Community Concerns

Proposed Development at 340 Parkdale Avenue, Hintonburg

Application D01-01-26-0002 — Taggart Realty Management — 38 Storeys, 465 Units

Figure 2
Example of Set-backs

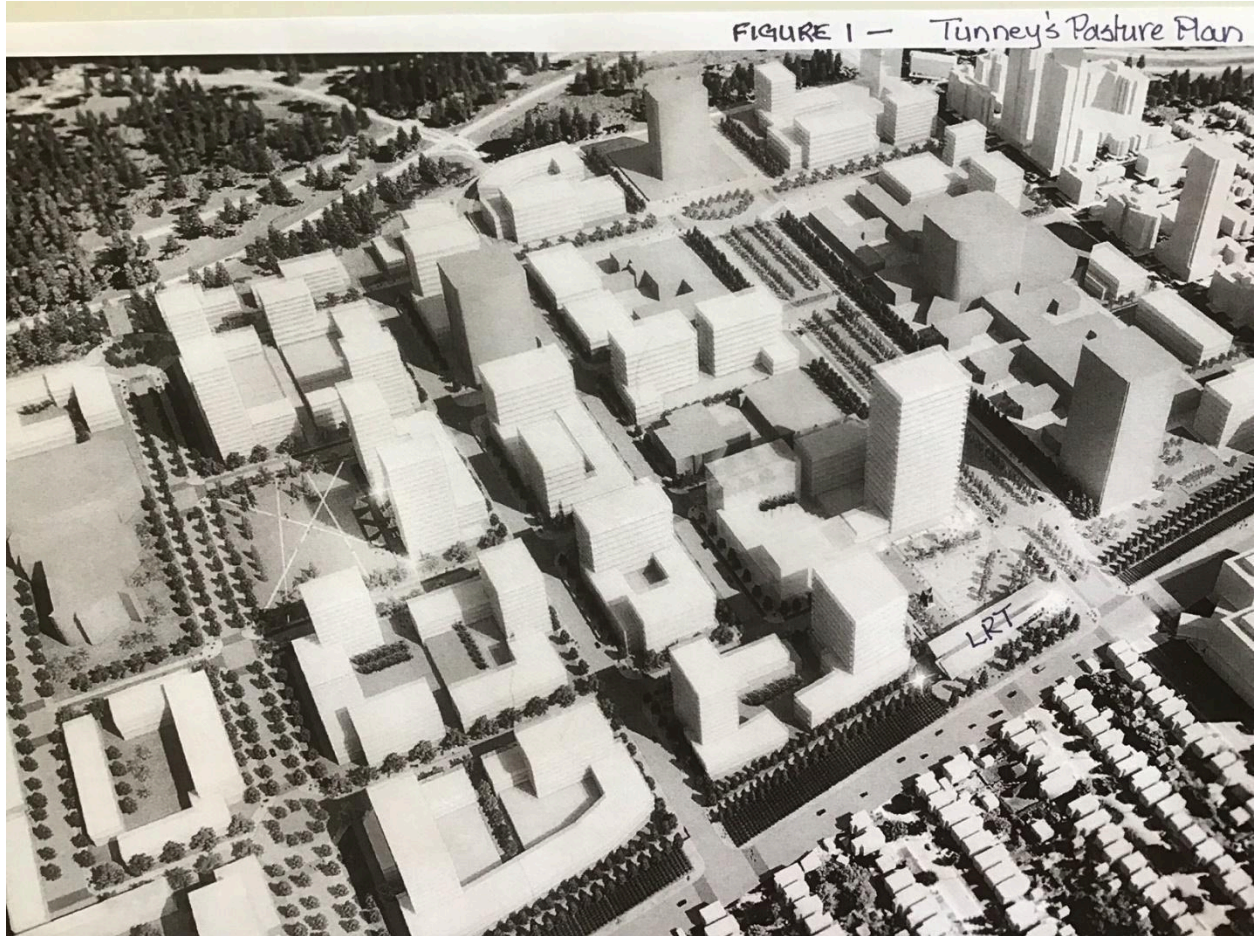
- **Reduce the Canyon like effect which under the current design will occur on Spencer St., by using setbacks on the podium at floors 3,5,7 and 8 on both Spencer St. and Parkdale Ave. (see Figure 2, a schematic drawing identifying how such step-backs might look).**

This will make the building appear more gradual and less abrupt; more sky would become visible between levels; the upper floors would visually dissolve into the skyline and the perceived height of the podium would be reduced. This is very much in line with accepted urban design principles for mid-rise developments.

Figure 4

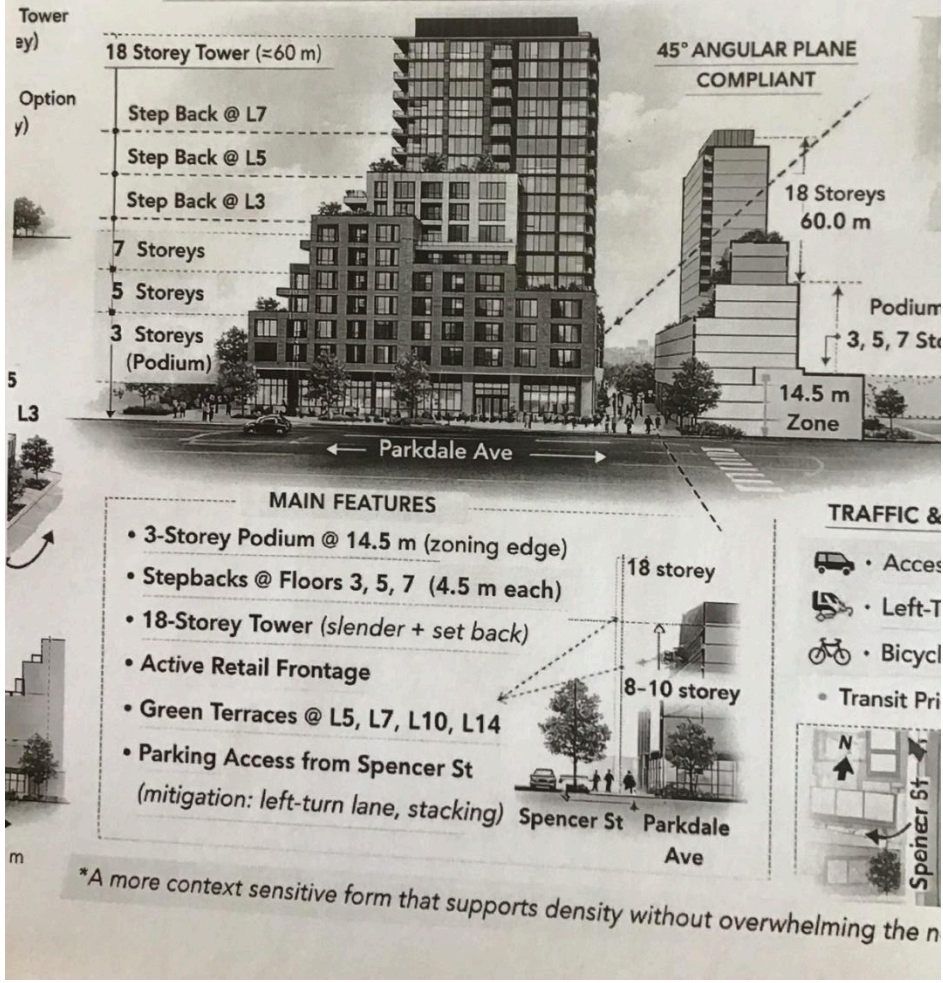
The Shadow Impact as noted above changes significantly between an 18 storey and 38 storey building. In mathematical terms, a 38 storey building casts a 2.1x shadow length of an 18 storey building. This is yet another important consideration in relation to site context compatibility. To understand the real impact on the low-rise and mid-rise residential homes to the north and east

Figure 4 is a representative schematic which shows the visual difference between an 18 storey and 38 storey building with the same Podium design from the surrounding area. This is not showing the specific proposal site.

of the site, it is suggested that the City ask the Applicant to prepare a comparative shadow study showing same date/time set for an 18 storey alternative massing and a 'net new shadow' overlay comparing 18 versus 38 storeys.
